*Amndt. 104
to DPR-37*

The Commission has issued the enclosed Amendment No.104 to Facility Operating License No. DPR-32 and Amendment No.104 to Facility Operating License No. DPR-37 for the Surry Power Station, Unit Nos. 1 and 2, respectively. The amendments consist of changes to the Technical Specifications in response to your applications transmitted by letter dated March 16, 1982, as supplemented June 28, August 3, and August 9, 1982, June 30, and October 27, 1983, March 22, and November 2, 1984, and April 17, and August 30, 1985; and by letter dated November 30, 1984, as supplemented April 12 and August 30, 1985.

These amendments revise the Technical Specifications to reflect changes to the VEPCO offsite and the Surry Power Station organizations, and revise the immediate notification requirements and the Licensee Event Reporting System to be consistent with Sections 50.72 and 50.73 of 10 CFR Part 50.

AMENDMENT NO. 104 FACILITY OPERATING LICENSE NO. DPR-32

T.S. Fig. 6.1-1

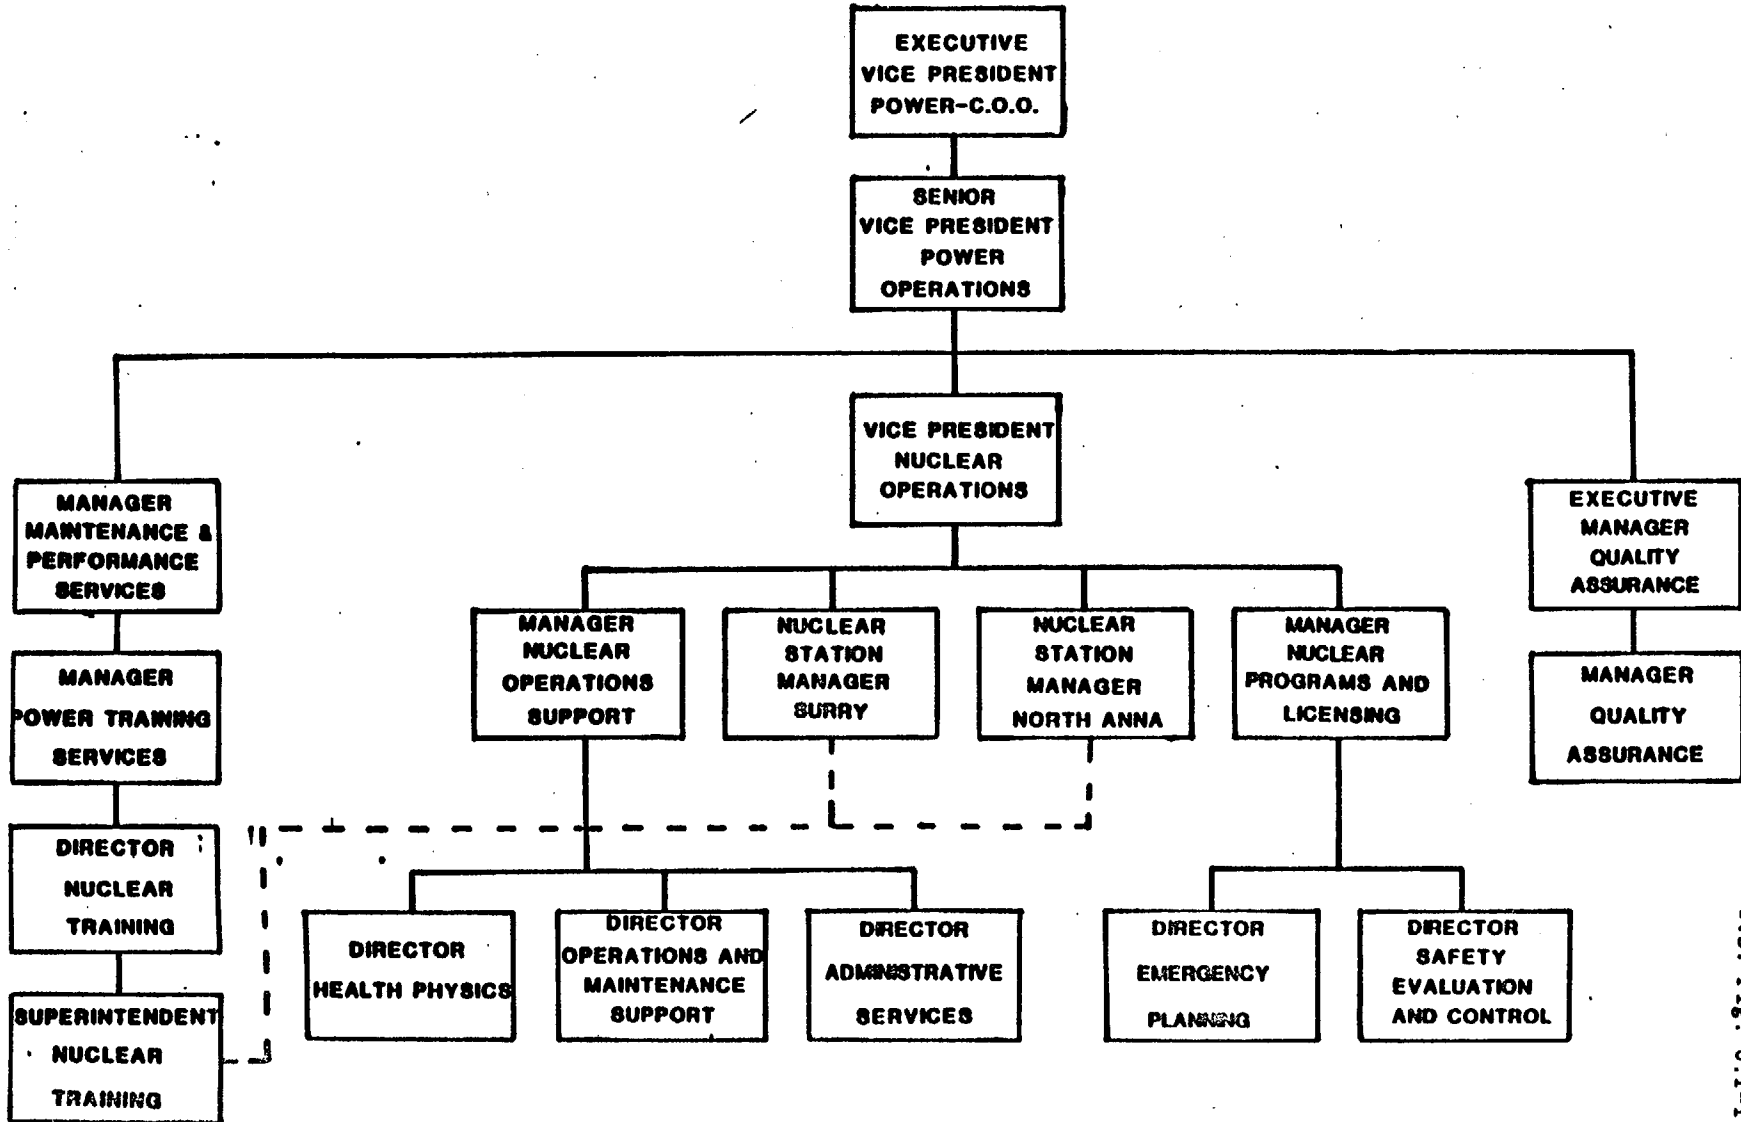
We have reviewed the proposed changes and find them acceptable as they meet the acceptance criteria of Sections 13.1.1, 13.1.2, and 13.4 of NUREG-0800, the Standard Review Plan. Technical Specification Figures 6.1-1 and 6.1-2, as revised, show the reorganized offsite and onsite management organizations.

- A. The Station Manager shall be responsible for the overall operation of the facility. In his absence, the Assistant Station Manager (Operations and Maintenance) shall be responsible for the safe operation of the facility. During the absence of both, the Station Manager will delegate in writing the succession to this responsibility.
 1. The off-site organization for facility management and technical support shall be as shown on TS Figure 6.1-1.
